November 2017  
FL746A  
NHTSA #17V-588  
Transport Canada #2017-460

**Subject: Western Star Battery Cable Routing**

**Models Affected: Specific Western Star 4700 model vehicles manufactured December 17, 2012, through July 14, 2017, with all wheel drive front axles.**

**Fig. 1, Battery Cables Near the Driveline**

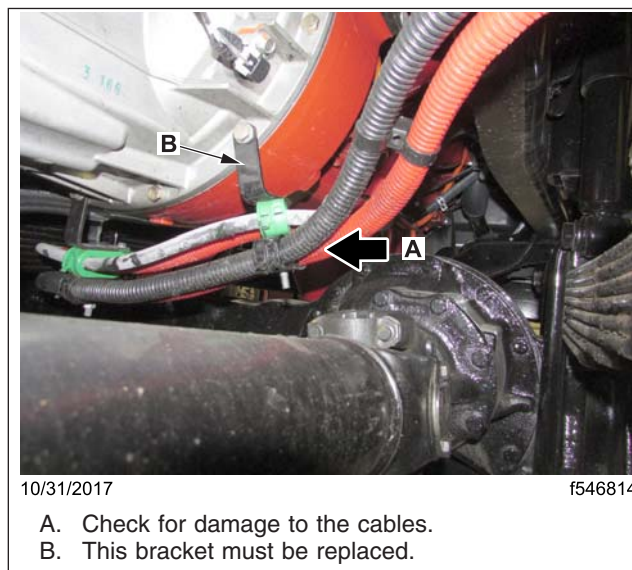
On certain vehicles, articulation of the All Wheel Drive (AWD) axle yoke may create an interference between the AWD yoke and the battery cable routing. An interference between the battery cables and the yoke may cause shorting of the lines and a possible fire.

4. If the battery cables are not damaged, Continue with step 5.  
If the battery cables are damaged (not just the convolute tubing), the battery cables must be replaced. Go to **Battery Cable and Bracket Replacement** on page 8.
5. Loosen the nut on the battery cable clamps to the left of the driveline. This will allow for any needed slack when positioning the cables on the new bracket.

**Fig. 5, New Battery Cable Installation**

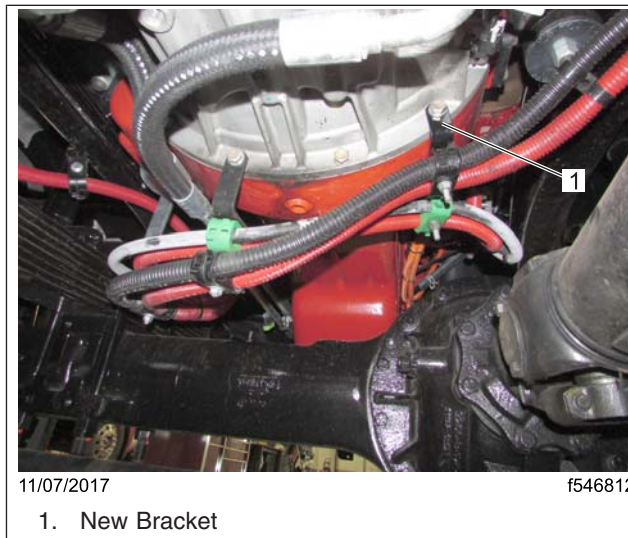
4. Remove the bracket above the driveline and install the new bracket supplied in the kit.
5. Install the battery cables starting at the d-pop stud, and running along the same route as the original installation. Mount the cables on the new bracket, as shown in [Fig. 5](#), with the two clamp groups side-by-side. In this installation, the battery cables are to the rear, and the alternator cables are forward.

6. Install any cable ties removed during the procedure.
7. Check along the length of the cables for any signs of rubbing, and adjust as needed.
8. Torque the cable at the starter 18.1 to 10.3 lbf·ft (24.5 to 27.5 N·m).
9. Torque the pass through nut on the d-pop 5 to 7 lbf·ft (6.75 to 9.49 N·m).
10. Apply grease to the d-pop stud, and red enamel to the starter studs.
11. Connect the battery cables at the batteries in the in-cab battery box.
12. Clean a spot on the base label (Form WAR259). Write the recall number, FL746, on a completion sticker (Form WAR260), and attach it to the base label to indicate this campaign has been completed.
